# Release A CDR RID Report

<b>RID ID</b>	<b>CDR</b>	61
<b>Review</b>	SDPS/CSMS	
<b>Originator Ref</b>		SB-03
<b>Priority</b>	2

**Subject** GUI Design Approach Missing Operations Concept

***Figure 6.5.2-3. Description of the Three-Step ECS GUI Design Process.***

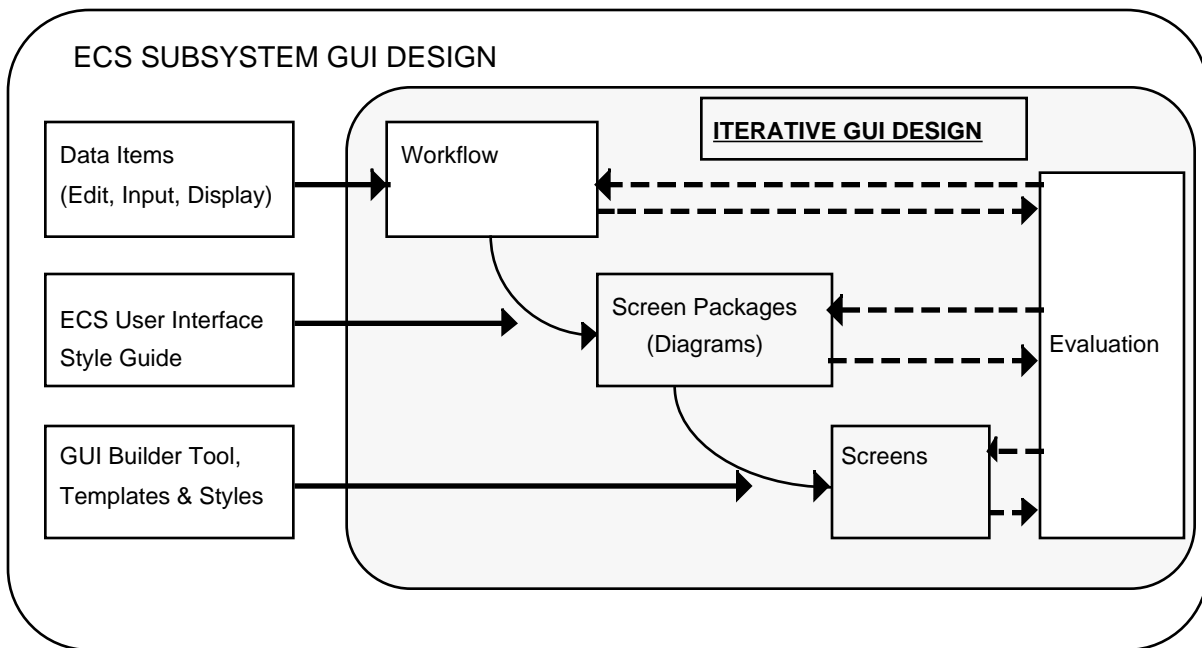
The GUI design approach is missing application of Release A Operations Concepts (i.e., DID 604, Part 2A).

Modify GUI design approach to include application of Release A operations concepts.

We concur with the comment presented in the RID. In fact, it has been our position that the available documentation defining the ECS Operations Scenarios are an integral part of the documentation that is reviewed in preparation for development of operator workflows, as described on page 6-69 and as depicted in Figure 6.5.2-3 (attached) of 305-CD-004-001. The figure identifies, in the upper left hand corner, a Data Input box as a lead-in requirement for the preparation of these workflows, as part of the overall GUI Design Process.

The text in this volume failed to adequately specify the documentation that is used as an input to determining the operator's information requirements. As stated in the text, information requirements provide the basis for the development of operator workflows in accordance with the project's workflow analysis procedure. The workflows are used to direct the development of the GUI screens. The text in this volume will be revised to identify the following types of documentation that are to be used to identify operator/user data information requirements:
